## SERVICE LETTER 256

### 208/208B on 8000/8750 Floats – Add Protective Sleeve to Water Rudder Steering Cable Spring

Aircraft Makes/Model(s):	Float Model(s):	Compliance: Mandatory	By: MAS
Textron Aviation 208 and 208B	8000 and 8750 Series	Part Number: 1012384	Approved: DRH
		Date: 8/29/2023	Revision: A

Figure 1 – Overview, Looking Up Through Tailcone Access Panel

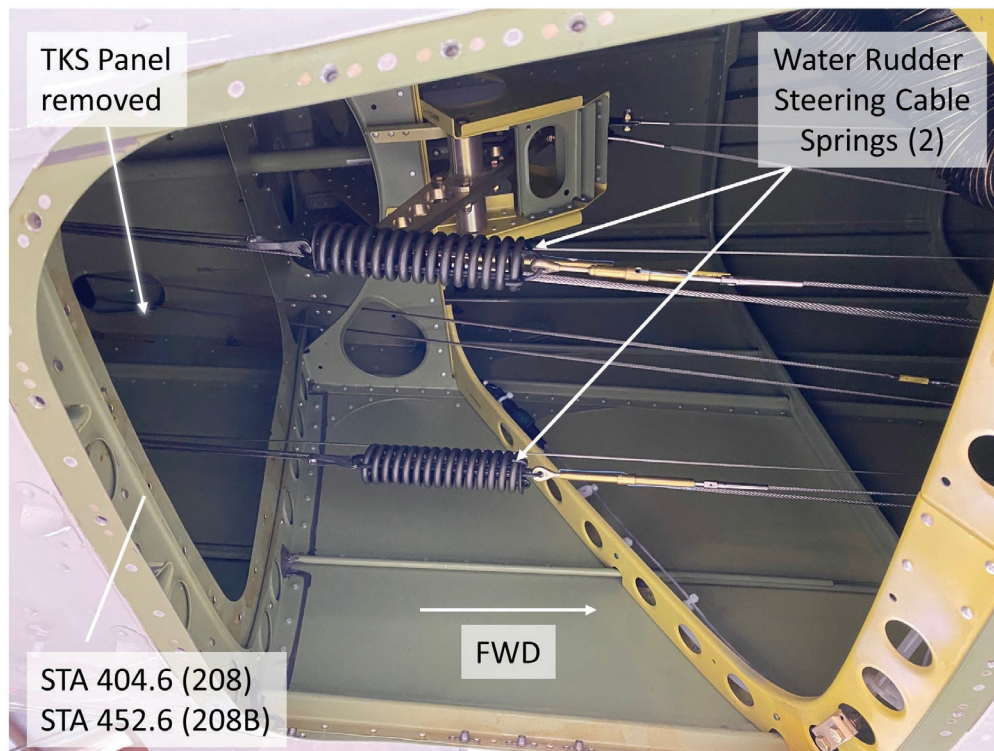
Water rudder steering cable springs located within the aircraft empennage may catch on the flange of an adjacent bulkhead, potentially affecting control of the aircraft.

1. Position and prepare aircraft for safe maintenance.
  2. Remove tailcone access panel located ahead of FS 404.6 (208) / FS 452.6 (208B). Refer to Figure 1.
  3. If present, remove TKS panel from bulkhead at FS 404.6 (208) / FS 452.6 (208B).
- Note:** Earlier revisions of Wipaire Install Drawing 1004806 described trimming this panel for clearance rather than removing it. It is to be removed as part of this Service Letter regardless. Panel is reinstalled if converting to landplane.
4. Install 1012383 spring sleeve around each water rudder cable spring using 1002267 cable tie, or equivalent. Refer to Figure 2.
  5. Reinstall tailcone access panel.

Install protective sleeve around the spring/drawbar assembly as described in the work instruction section of this letter.
